INITIAL FIRE SAFETY INSPECTION REPORT

FAKIR KNITWEARS LTD. (Extension - 2)

RSC ID: 25930

Date: 22 December, 2024

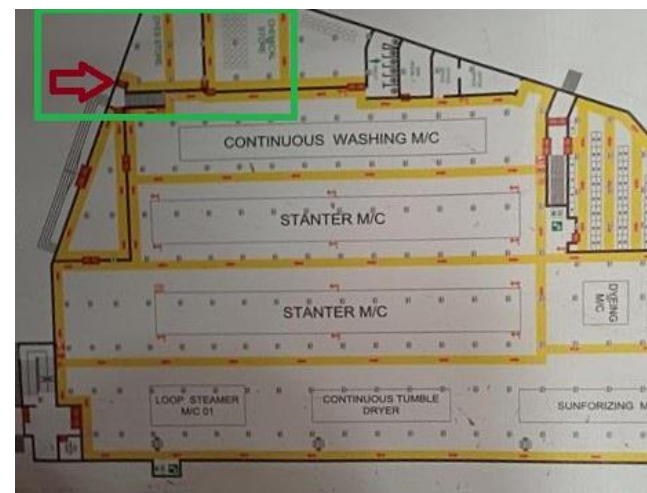
Sl No.	Category	Findings	Required Action	Remediation Time Frame
F1	Means of egress	The exit stair enclosures are not separated from work areas and other spaces on each floor by fire-rated construction (N-E Exit enclosure-2 on Ground floor, N-W Exit enclosure-1 on 2nd floor and S-W exit enclosure-4 on 2nd floor). Penetrations through ceiling is also observed at 1st floor S-E Staircase-3. Fire rated doors are not interfaced yet with FACP (Installation on-going). Location: Building-12	Provide minimum 2-hr fire rated construction for buildings 4 storied or more and 1-hr for up to 3 storied. Seal all unprotected openings to separate the exit stairs from work areas and other spaces on all floor levels by 90 minutes for 2 hr. construction and 60 minutes for 1-hr construction. Ensure that the fire-rated doors are self-closing and positive latching and that they are provided with fire exit (panic) hardware where serving production floors. If fire-rated doors are required to be held open for functional reasons, provide automatic closing devices tied to the fire alarm system.	Within 3 months

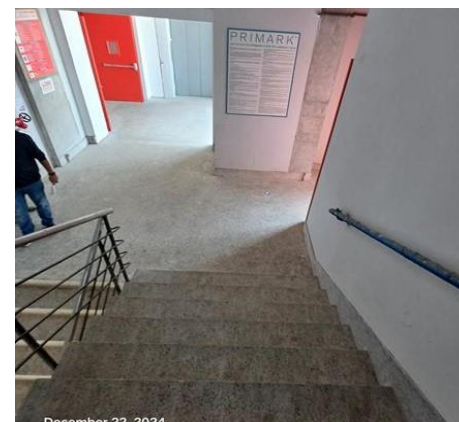
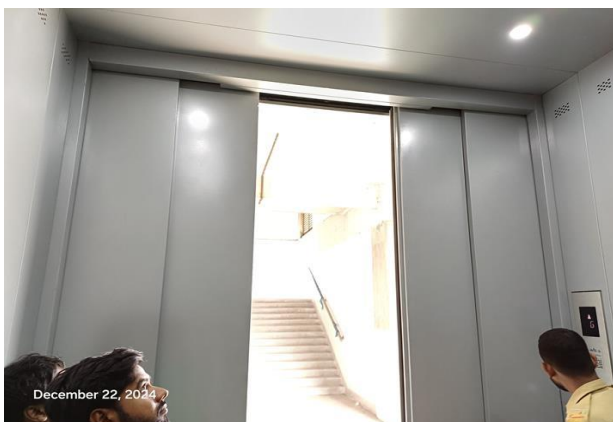
SI No.	Category	Findings	Required Action	Remediation Time Frame
F2	Fire Rated Construction	Penetrations through floor/ceiling assemblies (Both electrical riser and plumbing pipes) are found unsealed. Location(s): Building-12, 1st & Mezzanine Floor	Provide a minimum 2-hr fire-rated shaft to separate the utility risers from each floor level or seal all penetrations and openings in floors/ceiling assemblies by 3-hr fire-rated listed/certified materials. The installation of such fire-rated materials shall be following certified design.	Within 3 months

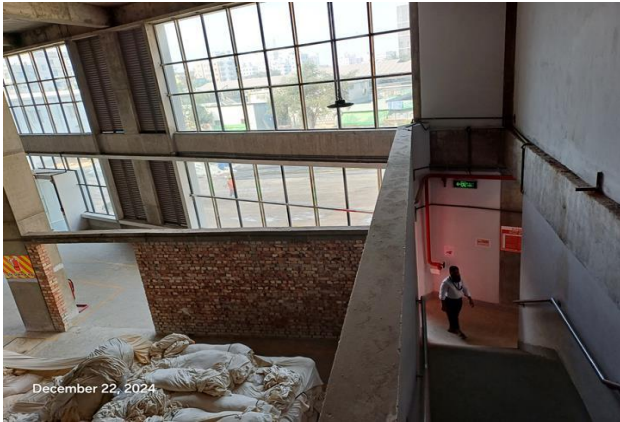
SI No.	Category	Findings	Required Action	Remediation Time Frame
F3	Means of egress	Ground Floor fabrics storage room and chemical store discharges directly into South-east exit enclosure-3 and North-east exit enclosure-2 on ground floor.	Openings from exit enclosure to storage room spaces shall be provided with a vestibule with fire rated construction and openings. Provide a 1.5 hr. fire rated door on the exit stair side and a 1-hr. fire rated door on the Store room side. Ensure that the fire rating of the vestibule construction matches that of the exit stair enclosure.	Within 3 months

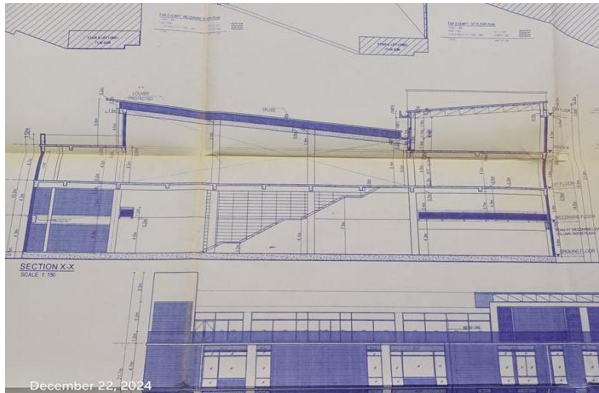
SI No.	Category	Findings	Required Action	Remediation Time Frame
F4	Means of Egress	Elevator shafts are directly open into North-west exit stair enclosure-1 and South-west exit enclosure-4.	Modify the elevator shaft as per RSC Technical Guideline (Standard) V1-6.14.3. An exit stairway shall not be built around a lift shaft unless both of them are located in a smoke proof enclosure and made of a material with fire resistance rating required for the type of construction of smoke proof enclosure. So, rearrange the facility to provide separate enclosure for lifts. If not possible anyway then provide a minimum 2-hr fire- rated elevator shaft with listed fire rated lift landing door to separate from each floor level.)	Within 3 months

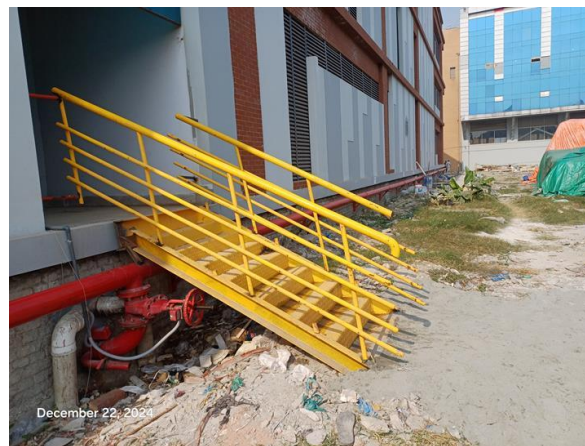
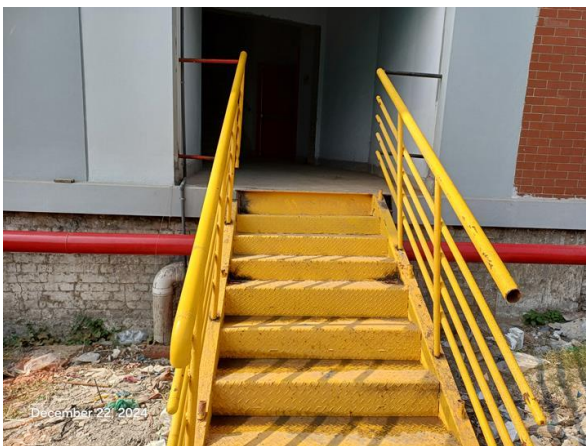
SI No.	Category	Findings	Required Action	Remediation Time Frame
F-16	Fire Rated Construction	Portable fire extinguisher are not installed inside 2nd floor unoccupied area. Few installed portable fire extinguishers are not mounted properly. Location: Building-12	Portable fire extinguishers shall be installed throughout all new, interim, and existing facilities in accordance with BNBC 2020 and NFPA 10. Extinguishers shall be placed so that maximum travel distance to the nearest unit shall not exceed 30 m (100 ft). Fire extinguishers having a gross weight not exceeding 18.14 kg (40 lb) shall be installed so that the top of the fire extinguisher is not more than 1.53 m (5 ft) above the floor (NFPA 10 6.1.3.8). The clearance between the bottom of the hand portable fire extinguisher and the floor be less than 4 in. (102 mm).	Within 3 months

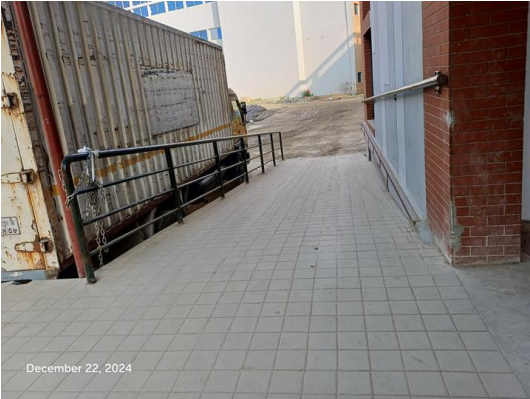
SI No.	Category	Findings	Required Action	Remediation Time Frame
F-21	Means of Egress	Width of stair is less than 60 inches. Location: discharge of south-east staircase- 3 (temporary Steel stair). Note that all four staircase has sufficient width	Construct stair in discharge in such a way that it shall have a minimum width of 1.5 m (60 in.) for all industrial occupancies.	Within 3 months

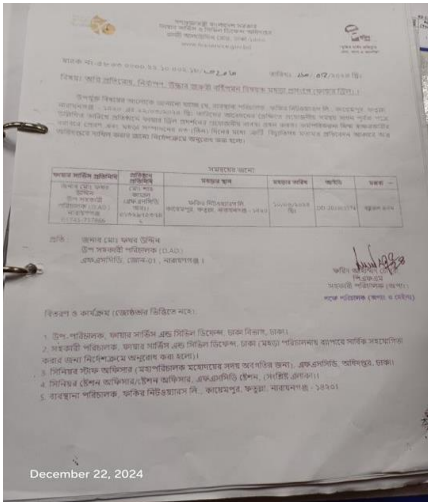
SI No.	Category	Findings	Required Action	Remediation Time Frame
F-22	Means of Egress	South and east side exit discharge path are unusable & abrupt changes of elevation in the walking surface have been found.	Provide an even level walking surface in exit discharge in accordance with 6.3.4 of RSC Technical Guidelines (Standard).	Within 1 month

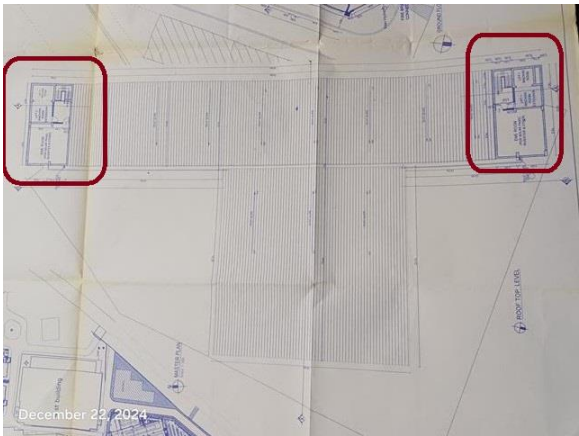
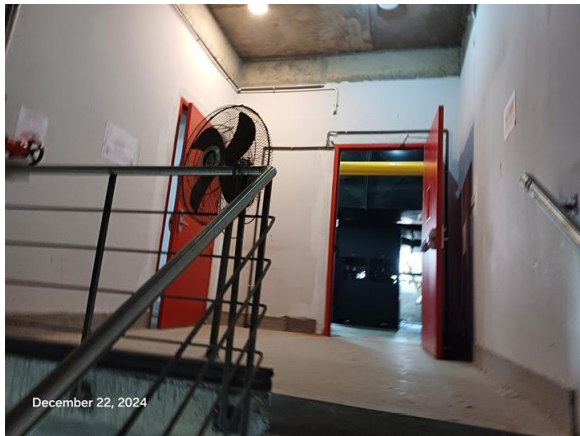
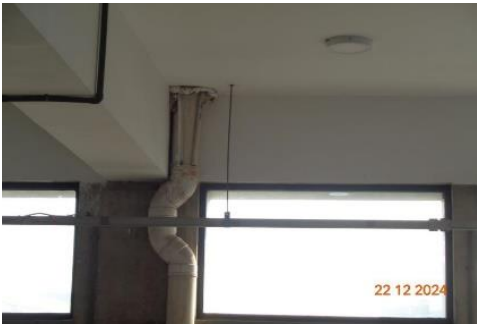
SI No.	Category	Findings	Required Action	Remediation Time Frame
F-26	Means of Egress	On 3rd floor, compressor room, lift machine room and unoccupied rooms at south-west and north-west part is provided with single exit stair.	The number of means of egress from any floor, story or portion thereof shall not be less than 2 except where a single exit is permitted by RSC guidelines 6.6.2, a single means of egress is permitted by RSC guidelines 6.6.5 or where a greater number is required by RSC guidelines 6.6.3.	Within 3 months
